Macquarie Point Stadium Project:

UDAP submission

Introduction

Image Source : Application doc_ PoSS scope boundary p18 Appendix-B-Stadium-Design-Description

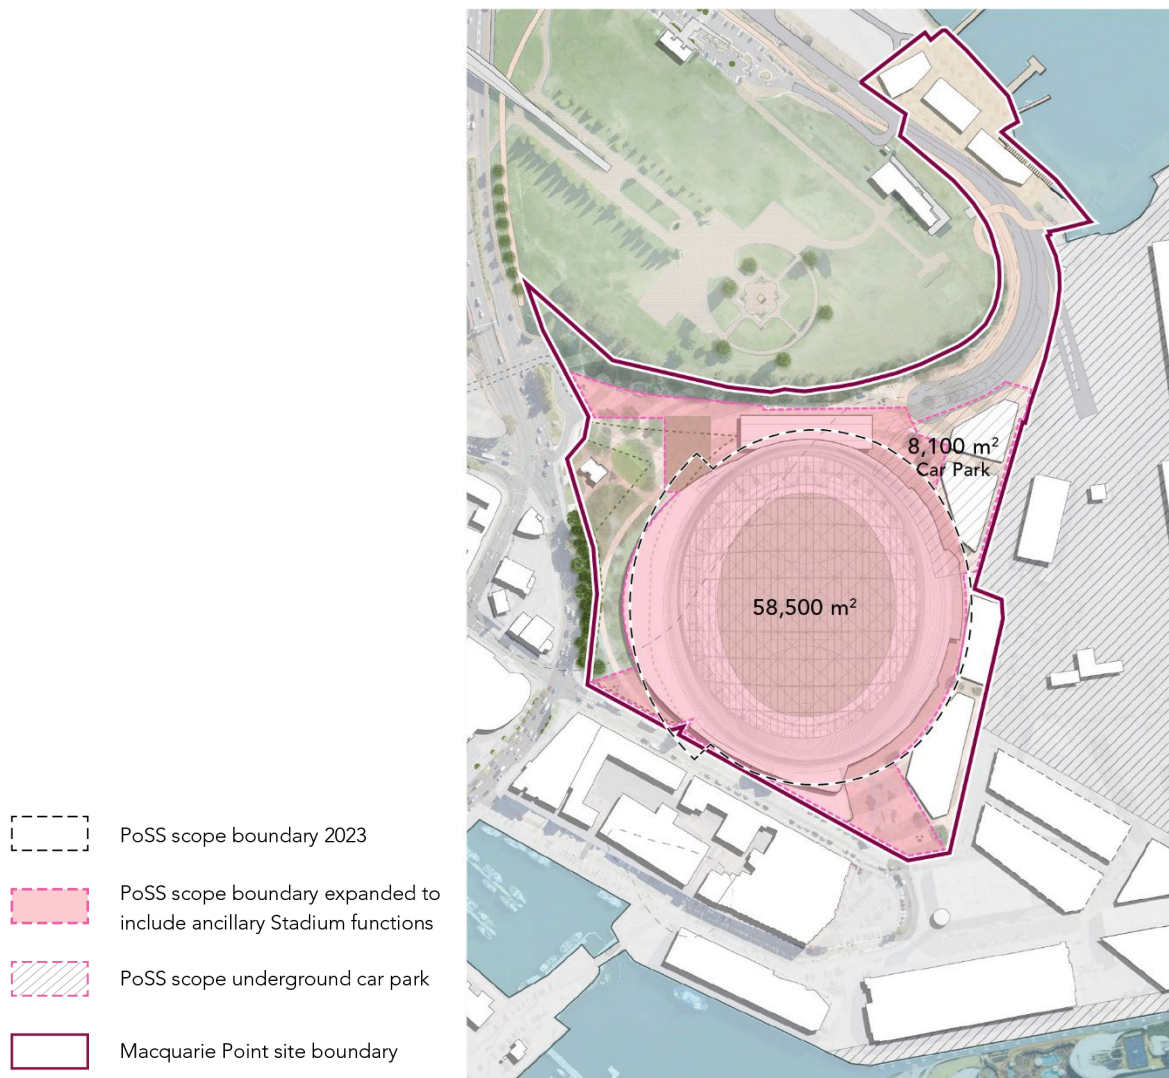
Both boundary limits exclude all other areas in the precinct from the POSS including landscaping of the headland escarpment and the Aboriginal Culturally Informed Zone, the Antarctic Facilities Zone and the Complementary Integrated Mixed-Use Zone. This potentially restricts our comment on urban design and landscaping design outside the scope of the POSS, which is critical to a relevant response.

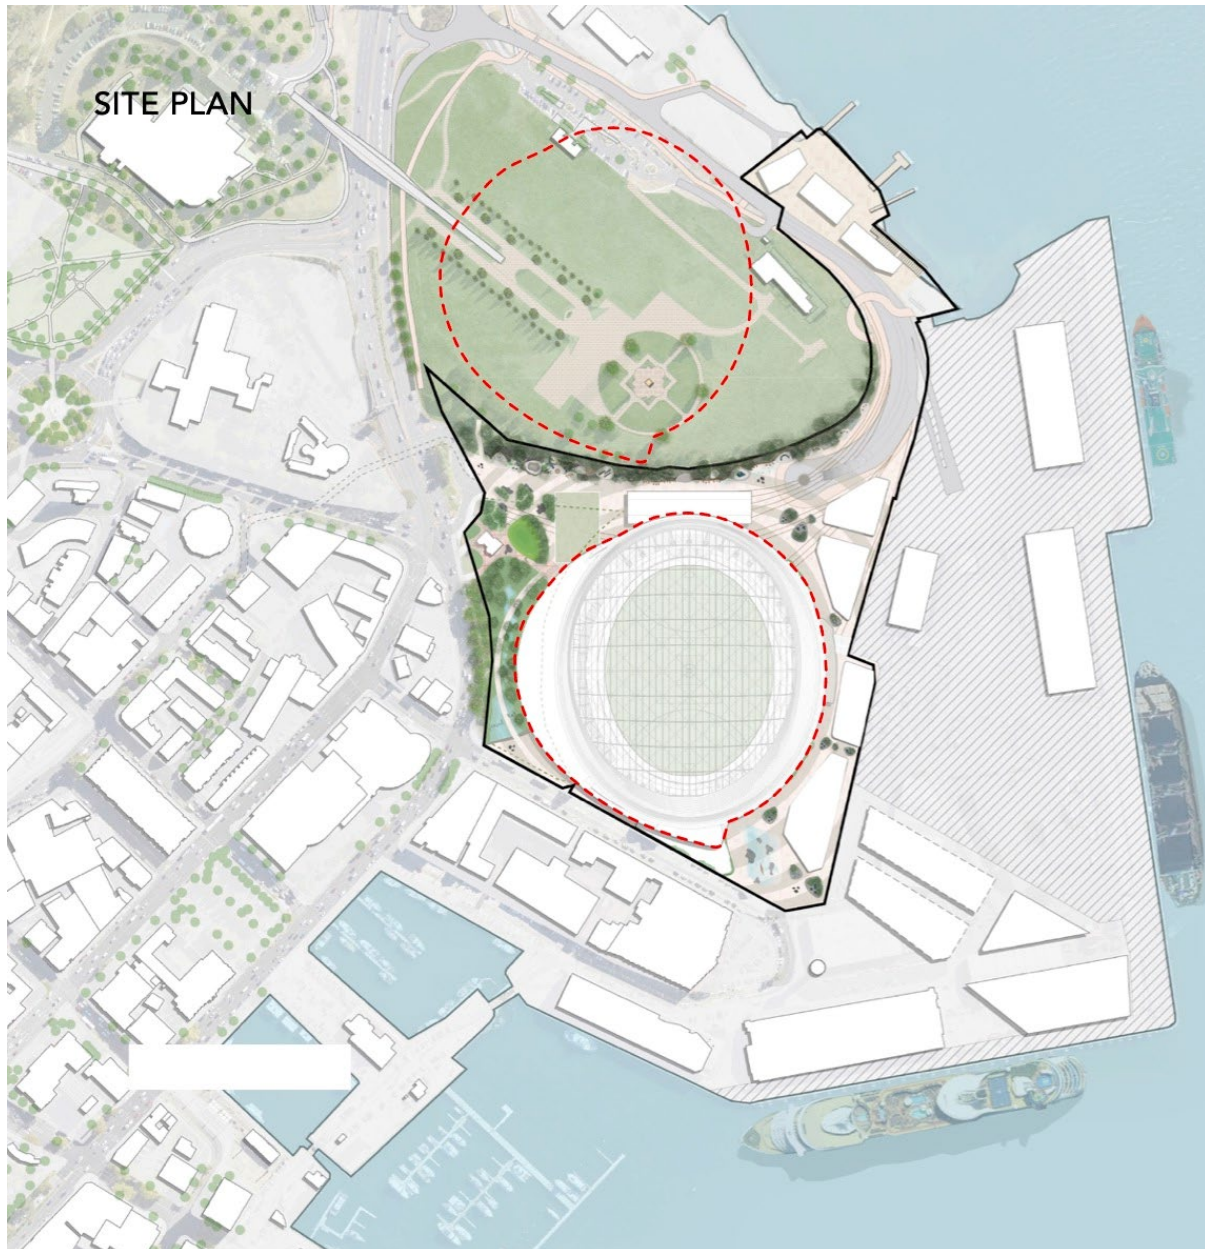
However, the scale of the stadium and lack of pedestrian permeability across the site due to its footprint, combined with the minimised and compressed adjacent public space on the perimeters of the site overrides any argument that could support the appropriateness of the building type, a Stadium, in this location.

The point has been made in this report that, in this location, the proposed Stadium will dominate and detract from the historic texture of the city. Similarly, its height, bulk and scale will significantly impact and diminish the spatial experience and symbolic prominence of the Cenotaph memorial.

Image source: Sullivans Cove Planning Scheme 1997 Amendment incorporating 32.0 Macquarie Point Site Development Plan - Important Views and Sightlines p193 overlayed over Application document Building Envelop Heights diagram p43 Appendix-I-Urban-Design-Framework-August-2024

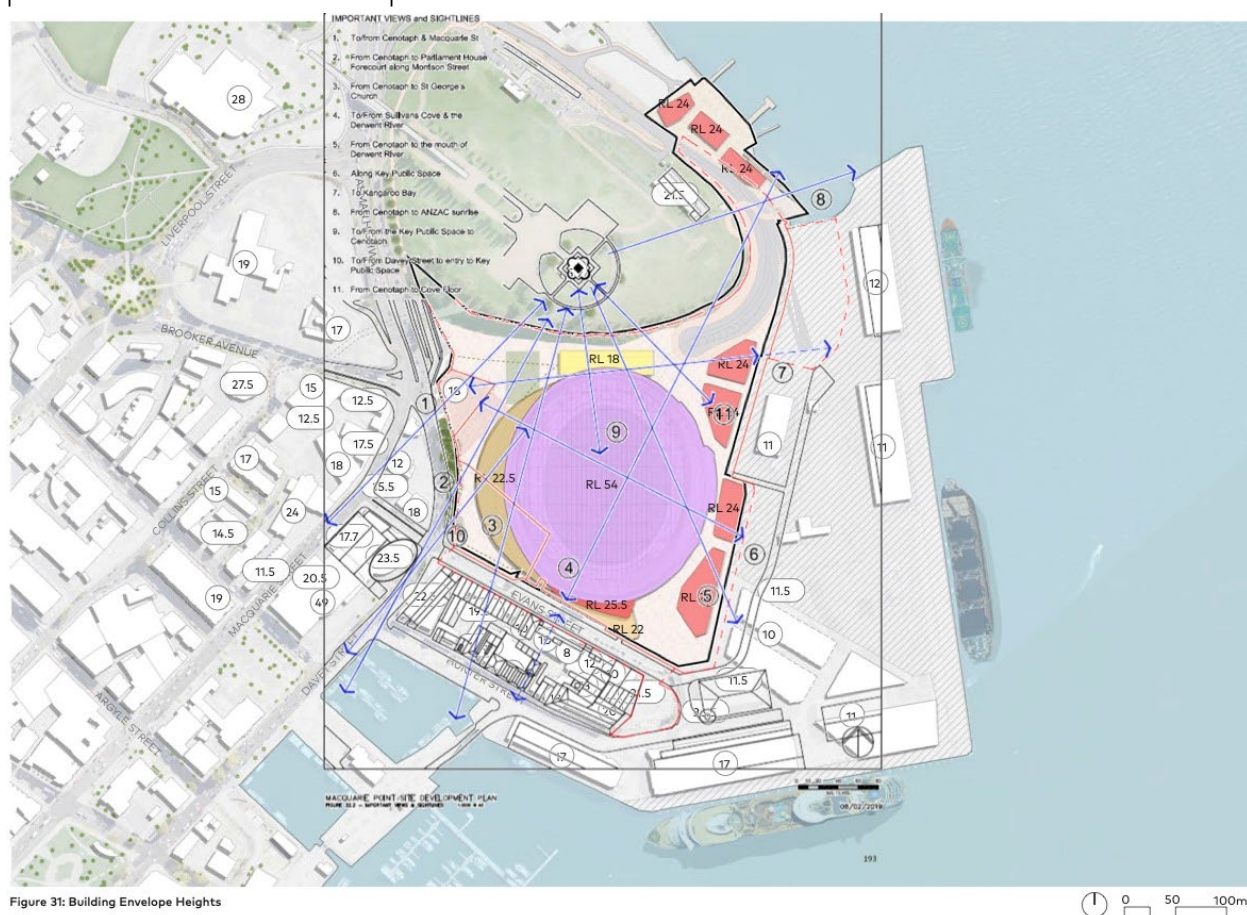
While the apex of the Cenotaph is referenced and listed at RL45.9 in the Application drawings (*1.3 Proposed use and development Building Envelope Heights Appendix-I-Urban_Design_Framework_August 2024*) this height reference should not be construed as the datum by which to compare the Stadium dome height. By comparison to the Stadium, the “needle” form of the Cenotaph memorial is insignificant with little impact in contrast to the Stadium bulk. The Stadium dome springs from RL25.5 rising to RL54 above the headland ground level of ~RL24. This height, despite the mitigating domed roof form, will visually interrupt existing wide sweeping views across the city and aspects of the River Derwent from the Cenotaph detracting from the symbolic experience of a “place-based” representation of “home” to the fallen. The Cenotaph monument, location and memorial services may not hold value to all of the local community, and may, by contrast, be construed by some as symbolic of the colonisation of the Island, nevertheless maintaining the sanctity of the Cenotaph and environs remains of significance within sectors of Hobart’s current social and cultural community experience and is promoted within the Macquarie Point Masterplan: Reset Urban Design Notes (*Leigh Woolley 2017 - Appendix 4.2 Diagrammatic Review*).

The relative heights referenced are demonstrated in the *Application document - Site Section 01 Appendix-A-Architectural Drawings*

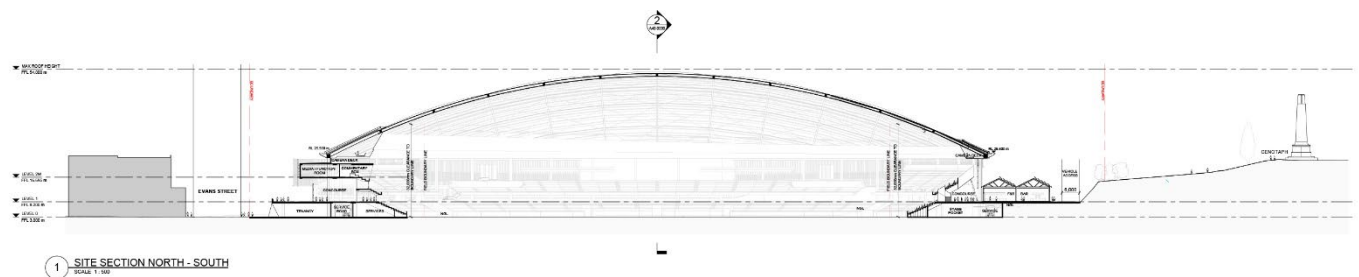
The analysis of the Application documents demonstrates that the proposed Stadium building height, bulk, and prominence compared to surroundings contradicts the stated Desired Future Characteristic Statements highlighted above.

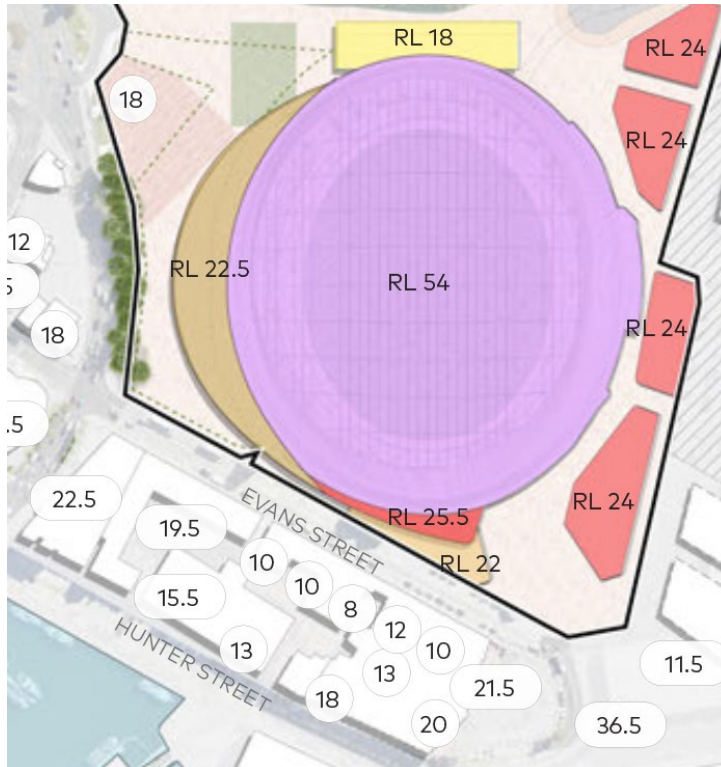
- The Application drawing *Site Section Perpendicular to Evans Street _ Site Section 03a Appendix-A-Architectural Drawings* includes graphic representation of the higher existing Evans Street building envelope heights of RL 19.5 and RL22.5 that occur towards Davey Street. However,

UDAP notes that the lower existing building envelope heights of RL10, RL8 and RL12 make up the greater proportion of the Evans Street facades opposite the Stadium and that it is opposite these smaller-scale buildings that the looming Stadium extends hard up against its Evans Street boundary.

Application document Figure 31 p43 Building Envelope Heights Appendix-I-Urban-Design-Framework-August-2024

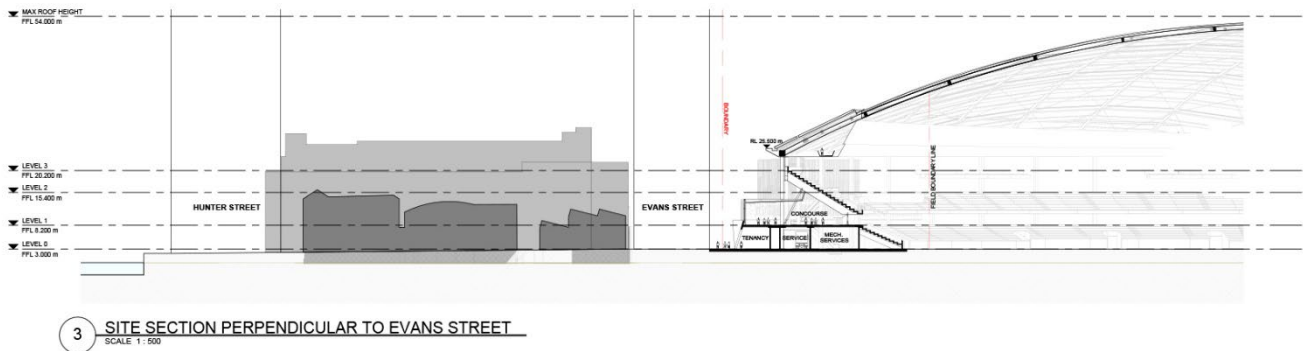
Furthermore, the full expanse of the continuous Stadium facade will be experienced visually along the entire length of one side of Evans Street by pedestrians in their approach to Gate 1 along Evans Street.

The above factors impacting in this manner together, would mean the likely significant diminishment of the human scale of the existing street fabric by the Stadium as proposed.

Figure 44: Hobart Yards in the 1960s. Uncredited, Stations of Tasmania. (Source: Macquarie Point Development Corporation)

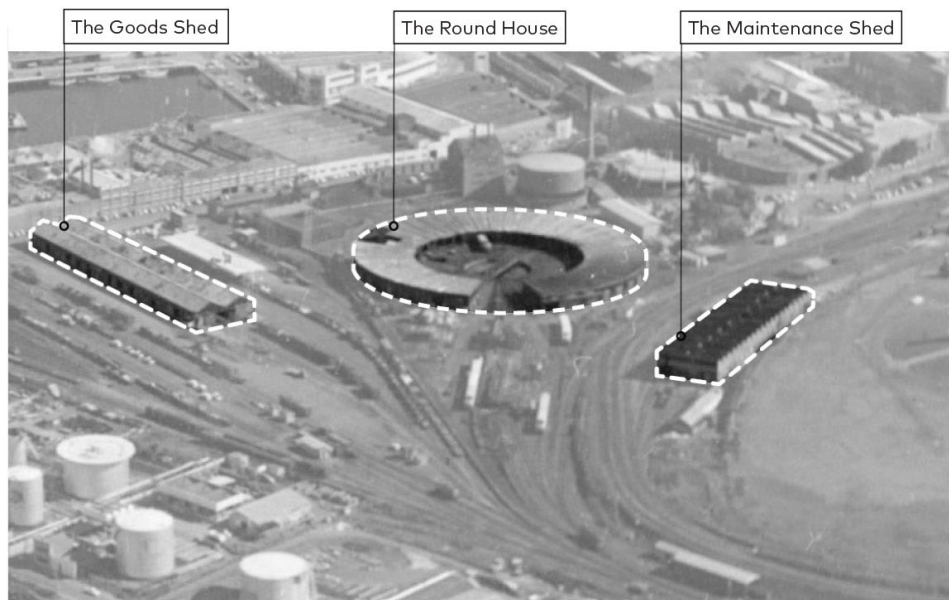
Of note when considering the former Round House as a precedent in regard to the project's all-round spatial and visual contribution, is the ratio of built form to the open space around it. By contrast, the ratio of the proposed Stadium bulk to the remnant compressed open spaces surrounding it once all development stages have been realised, it (particularly adjacent to the Port Authority site and the Cenotaph headland escarpment) will pose a significantly higher built form to open space ratio. The project's positive all-round spatial and visual contribution here is likely to be further undermined by the height and bulk of the Stadium compared with that of the Round House which historically did not obscure the all-round visual and topographic spatial experience of the Cove Floor. A digital model of the proposal will assist UDAP in making this determination.

Figure 45: The Good Shed preservation and relocation diagram (Source: Cox Architecture)

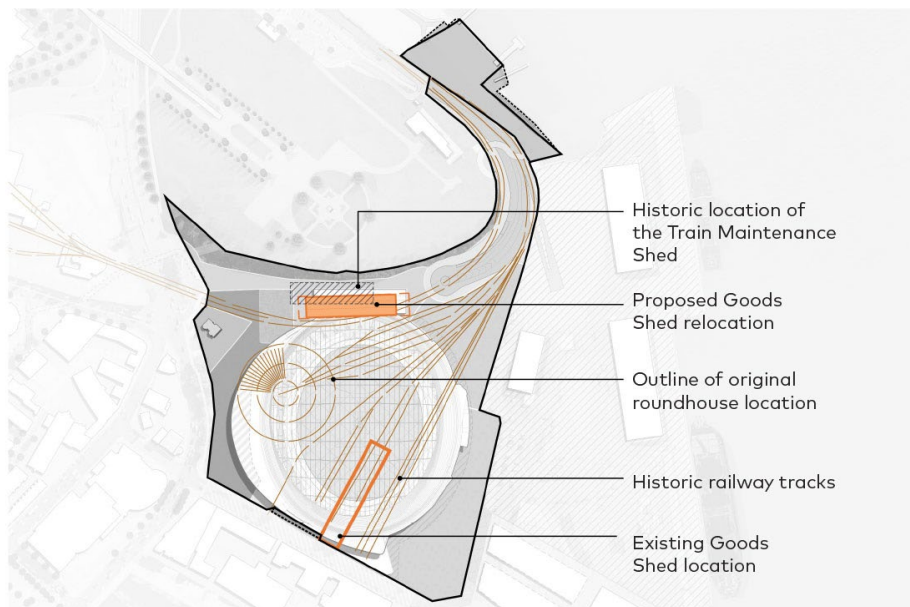
- Position of the Goods Shed at the rear of the building, between the stadium and the escarpment is clearly explained, but the spatial effect of this is questionable. The Goods shed is dwarfed by the stadium and in this location is buried deep into the site. This contrast in scale is very evident in both the sections and renders. UDAP suggest consideration of other opportunities for the placement of this building, in locations that would provide a better-scaled context.
